**ELECTRONIC REPORT TO GEORGES RIVER LOCAL PLANNING PANEL
FOLLOWING DEFERRAL FROM MEETING OF PANEL ON 20 JUNE 2019**

LPP Report	LPP016-19A	Development Application No.	MOD2019/0005
Site Address and Ward	42 Carwar Avenue Carrs Park Kogarah Bay Ward		
Proposed Development	MOD2019/0005 seeks retrospective approval of unauthorised works and alterations and additions to the approved dwelling		
Owners	Angela and Triantrafilos Karaberas		
Applicants	Angela and Triantrafilos Karaberas		
Planner/Architect	Planner: Dreamscape Urban Planning Architect: Gelder Architects		
Date of Lodgement	11/01/2019		
Submissions	Four (4) submissions were received during re-notification of amended plans		
Cost of Works	N/A - The works are to remedy construction impacts – the development has not yet been completed.		
Local Planning Panel Criteria	Development that contravenes a development standard imposed by an Environmental Planning Instrument by more than 10%		
List of all relevant s4.15 matters	State Environmental Planning Policy (Building and Sustainability Index: BASIX) 2004, State Environmental Planning Policy 55 (Remediation of Land) Greater Metropolitan Regional Environmental Plan No. 2 – Georges Rive

Figure 1: Extract of amended east rear elevation (Source: Gelder Architects, August 2019).

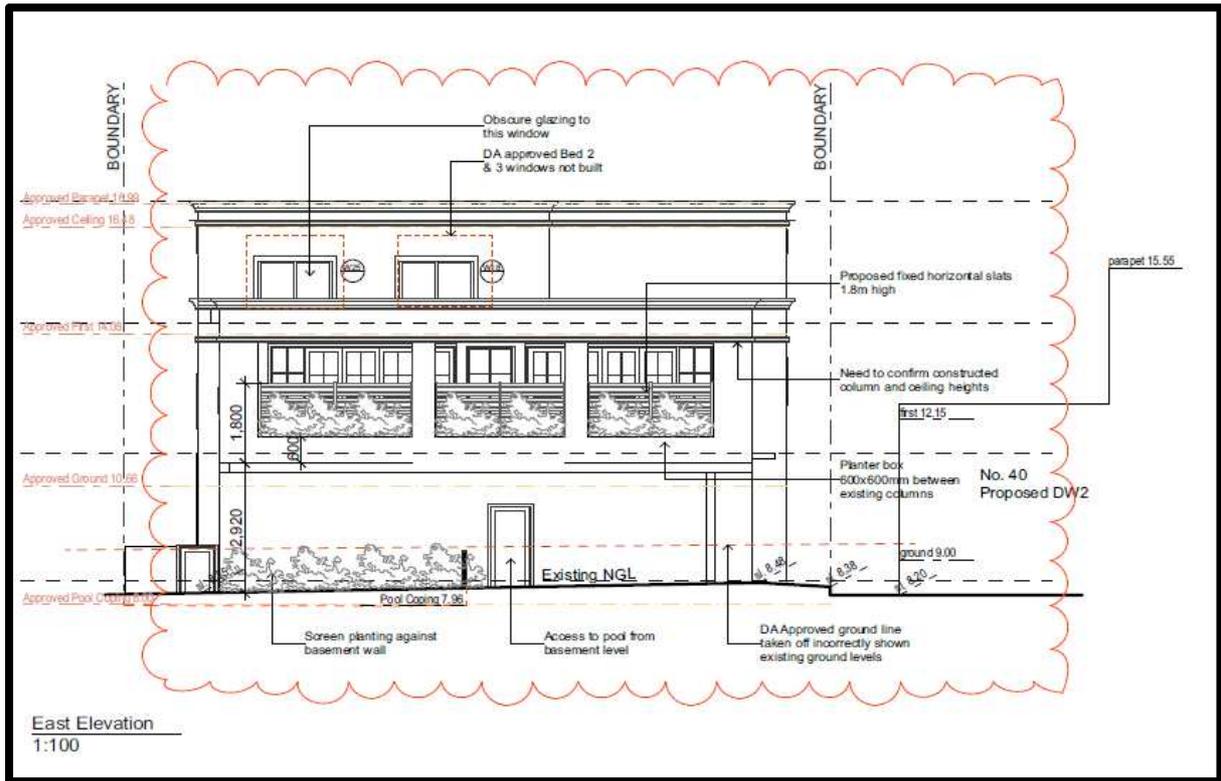
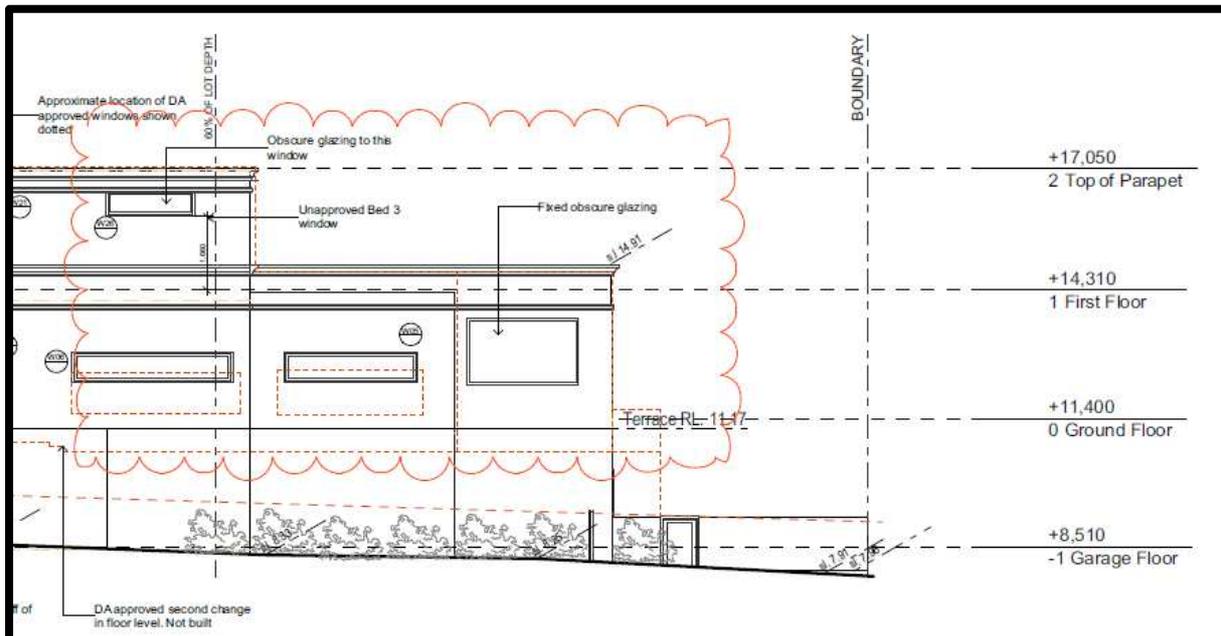
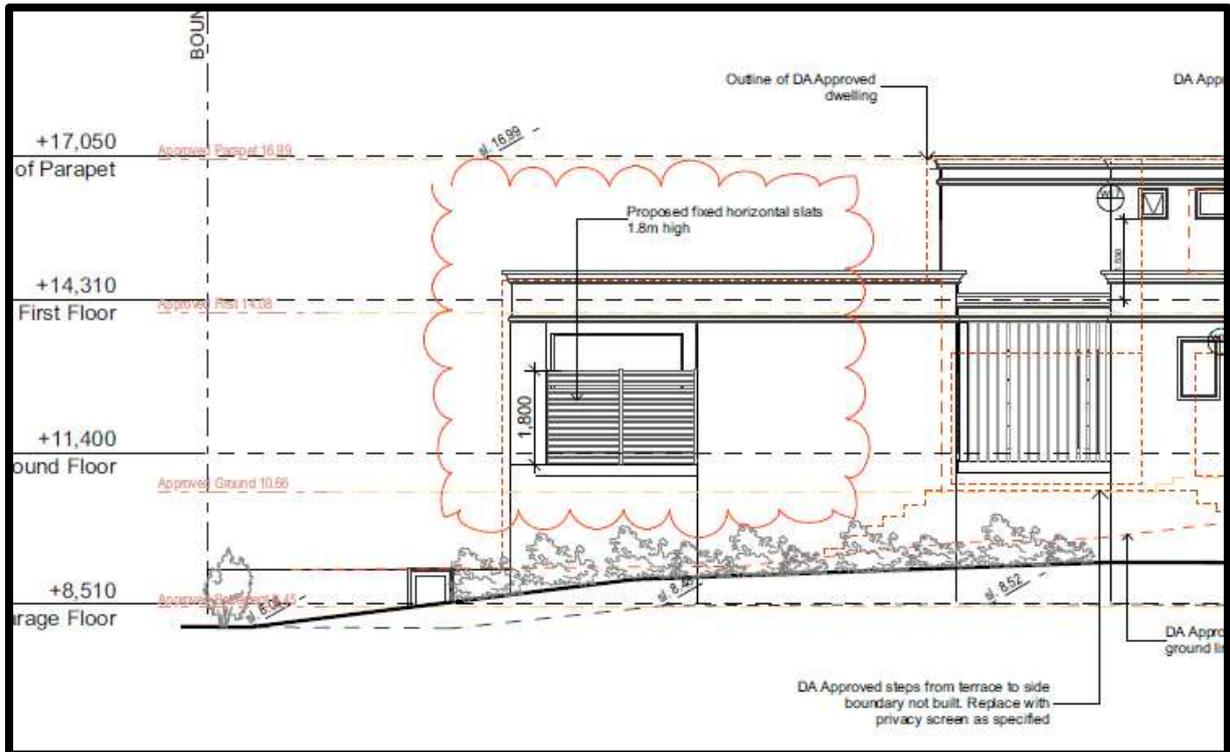
- (a) Provide fixed lightweight privacy screening (obscure glass or the like) around the northern and eastern side of the rear balcony to a minimum height of 1.8m. The screen along the eastern side of the rear balcony is to be set to the line of the rear of the columns with a planter box (600mm x 600mm) to extend between the existing columns.***
- (b) Provide fixed obscure glazing to the southern opening of the rear balcony.***

The amended proposal, as indicated on architectural plans prepared by Gelder Architects Rev C dated 7 August 2019 incorporates the required design elements.

Accordingly the matters raised in deferral reason 1 have been addressed.

It is acknowledged the submitters raised concerns with these amendments noting the development is non-compliant and the works a merely a ‘band aid’ solution and does not resolve the impacts of the development on the allotments adjoining.

However, it is acknowledged the amendments made were in direct response to this deferral reason. The amendments made satisfy this reason for deferral.

- a. Privacy screens and planter boxes. Fixed horizontal slats 1.8m high shown along northern side of the balcony.
Fixed horizontal slats 1.8m high shown along the eastern side of the balcony in line with the rear of the columns.
Planter boxes 600mm x 600mm shown between columns.***
- b. Fixed obscure glazing shown to the southern opening of the rear balcony.***

- (a) Delete the stair access from the balcony and provide access to the rear yard from the basement level. In this regard, the basement level shall not be filled.***

The applicant has provided revised architectural plans which demonstrate the deletion of the rear staircase which provided access from the northern side of the balcony to the rear yard (as depicted on Figures 1 and 3). Access to the swimming pool is provided by a pedestrian door from the basement.

It is noted that the Deferral Reason No 2 states that *“In this regard, the basement level shall not be filled”*. The provided plans do not indicate basement fill.

It remains the view of the assessment officer that the subfloor area of basement should be backfilled, and a condition of consent remains in the recommendation in

this regard (*Condition 40(a) Basement floor/backfill*). It is considered this area should be backfilled given the clearance in ground levels to the elevated ground floor underside slab and the potential for this area to be converted into usable floor space in the future. This inclusion of this area as habitable space results in a breach of the floor space ratio applicable to the site.

“Stair access from the balcony has been deleted and access to the pool is now provided from the basement”.

(a) Provide obscure glazing to windows W25 and W26 in Bedroom 2.

The applicant has provided obscured glazing to windows on W25 and W26 in Bedroom 2 on the amended architectural plans (*as depicted on Figures 2 and 3*). A revised BASIX Certificate (A345979_02 dated 30 July 2019 prepared by Greengauge) accompanies the amended proposal with the relevant window changes meeting the necessary targets.

- "a. Obscure glazing shown to windows W25 and W26 in Bedroom 2.*
- b. Amended BASIX Certificate attached showing latest changes to windows".*

Figure 4: Extract of newly provided landscape plan (Source: Paul Scrivener Landscape Architecture, Issue B dated 30 July 2019).

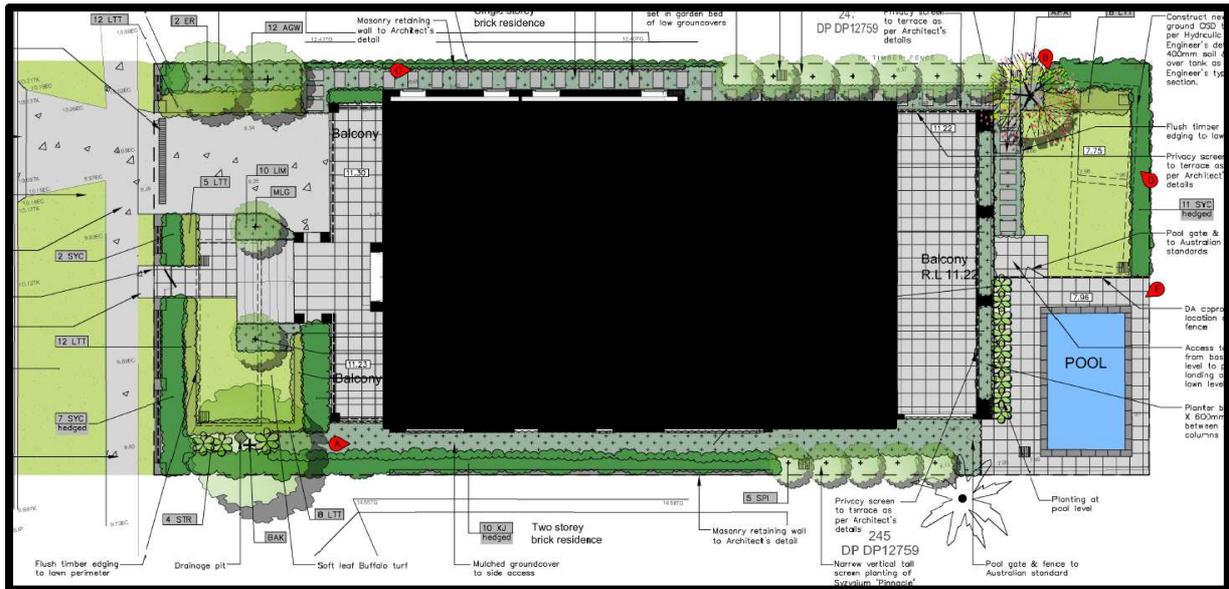
(a) Provide additional landscaping along the eastern and northern boundaries, or adjacent to the building, to increase screening of the rear subfloor area below the balcony.

(b) Provision of an amended landscape plan which addresses items 1 and 5 above.

The amended concept landscape plan prepared by Paul Scrivener Landscape Architecture provides additional landscaping along the northern side boundary (7 x Queensland Qondong, maturity height 7-10m), southern side boundary (5 x Pinnacle Lily Pilly, maturity height 3-5m) and eastern rear boundary (11 x Cascade Lily Pilly, maturity height 1.6 – 2.8m). Cascading ground cover is proposed in the 600mm high x 600m wide planter boxes along the rear eastern Elevation.

The amendments to the plans relating to landscaping satisfy the deferral reason number 4.

The amended landscape plan prepared by Paul Scrivener Landscape Architecture details *"masonry retaining wall to Architect's detail"* along both the northern and southern side boundaries (as depicted in Figure 4). Further structural details are required as part of condition 40(c) Retaining Walls/Structural Report.

- "a. Additional landscaping provided along eastern and northern boundaries, also along the western length of the pool to screen the subfloor wall from the balcony.*
- b. Landscape plan has been amended by the landscape designer".*
